[Docket No. FAA-2011-1158; Directorate Identifier 2010-SW-018-AD]

Airworthiness Directives; Eurocopter France Helicopters

ACTION: Notice of proposed rulemaking

Manual Check for Play of the Tail Rotor Pitch Control Rod Figure 1 to Paragraph (f)

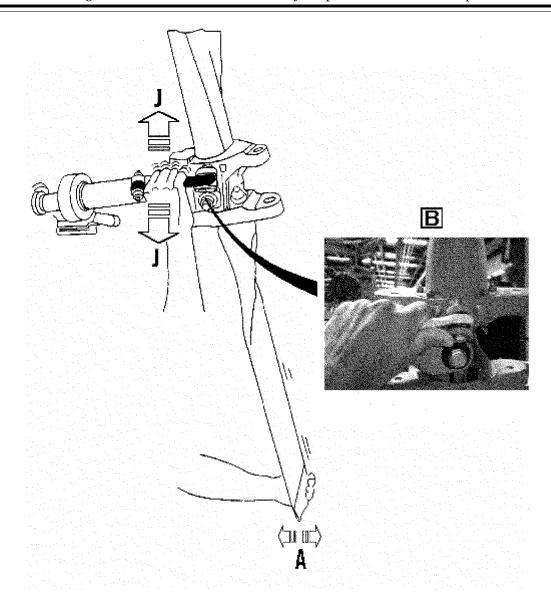
(1) Within 30 hours time-in-service (TIS) and, if no bearing play is detected, thereafter at intervals not to exceed 30 hours TIS, place the T/R pedals in the neutral position. If the helicopter is fitted with a T/R load compensator, discharge the accumulator as described in the rotorcraft flight manual. Check the control rod bearing (bearing) for play on the helicopter, by observation and feel, by slightly moving the T/R blade in the flapping axis while monitoring the bearing for movement. See the following Figure 1 to Paragraph (f) of this AD. The actions required by this paragraph of may be performed by the owner/operator (pilot) holding at least a private pilot certificate, and must be entered into the helicopter maintenance records showing compliance with this AD in accordance with 14 CFR 43.9(a)(1)-(4) and 14 CFR 91.417(a)(2)(v). The record must be maintained as required by 14 CFR 91.417, 121.380, or 135.439.

Measurement of the Axial Play (A) of the Bearing Figure 2 to Paragraph (f)

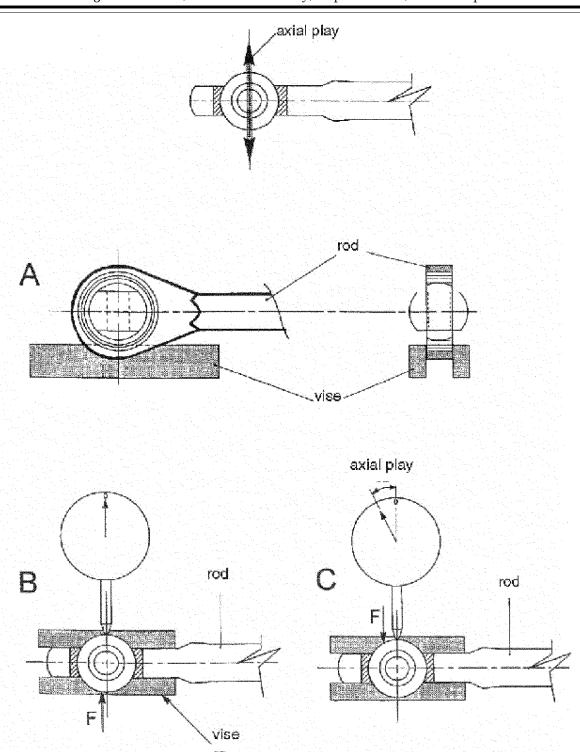
- (i) Remove the control rod from the helicopter.
- (ii) Mount the control rod in a vise as shown in Figure 2 to Paragraph (f) of this AD.
- (iii) Using a dial indicator, take axial play readings by moving the spherical bearing in the direction F (up and down) as shown in Figure 2 to Paragraph (f) of this AD.

- (vii) Record the hours of operation on each control rod.
- (viii) If the radial play exceeds 0.008 inch or axial play exceeds 0.016 inch, replace the control rod with an airworthy control rod before further flight.

Figure (3) to Paragraph (f)

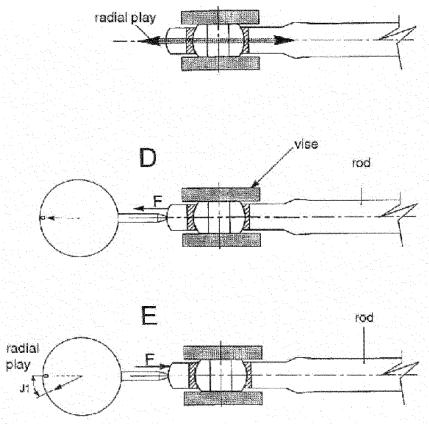
- (iv) Install a bolt through the bearing and secure it with a washer and nut to provide a clamping surface when the bearing is clamped in a vise.
- (v) Mount the control rod and bearing in a vise as shown in Figure 3 to Paragraph (f) of this AD.

- (vi) Using a dial indicator, take radial play measurements by moving the control rod in the direction F as shown in Figure 3 to Paragraph (f) of this AD.
